Access Compliance Report

Public Rights-of-Way

Intersection ID: 50607	Main Street: DENBUR_DR	Cross Street: STREAM_ORCHID_LN	Location: SE
ADA ID: 353D64F16794	Ramp Type: Perp	Initial Pass/Fail: Fail	Overall Compliance: No
Severity Score: 10			
Codes/Mitigation Info/Possible Solution		Field Measurements/Component Compliance

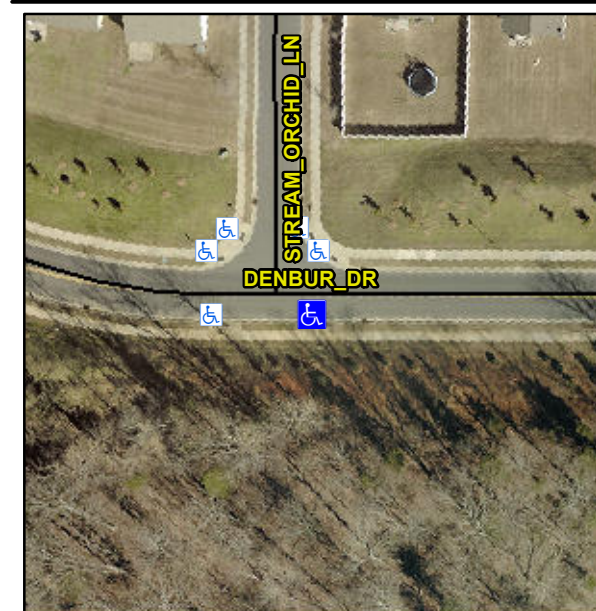
Not Found, R304.5.1

Compliance	Description	Data	Compliance	Description	Data
N/A	Ramp Length (in)	49.0	Yes	Ramp Slope (%)	7.3
No	Ramp Width (in)	47.5	Yes	Ramp XSlope (%)	3.3
N/A	Flare Type LT	N/A	N/A	Flare Type RT	N/A
N/A	Flare Slope LT (%)	N/A	N/A	Flare Slope RT (%)	N/A
N/A	Flare Traversable LT?	N/A	N/A	Flare Traversable RT?	N/A
N/A	Landing Length (in)	N/A	N/A	DWS Provided?	N/A
N/A	Landing Width (in)	N/A	N/A	DWS Contrast?	N/A
N/A	Landing Slope (%)	N/A	N/A	DWS Length (in)	N/A
N/A	Landing X Slope (%)	N/A	N/A	DWS Full Width?	N/A
N/A	Landing Curb? (Y/N)	N/A	N/A	DWS Offset (in)	N/A
N/A	Shared Landing?	N/A			
N/A	Gutter Ponding?	N/A	N/A	Gutter Slope (%)	N/A
N/A	Gutter Lip Ht (in)	N/A	N/A	Gutter X Slope (%)	N/A
N/A	Painted X Walk1?	No	N/A	Painted X Walk2?	N/A
	X Walk 1 Direction	To N		X Walk 2 Direction	N/A
N/A	X Walk 1 Width (in)	N/A	N/A	X Walk 2 Width (in)	N/A
	X Walk 1 Slope (%)	2.1		X Walk 2 Slope (%)	N/A
	X Walk 1 X Slope (%)	3.5		X Walk 2 X Slope (%)	N/A

Remove & Replace Entire Ramp.
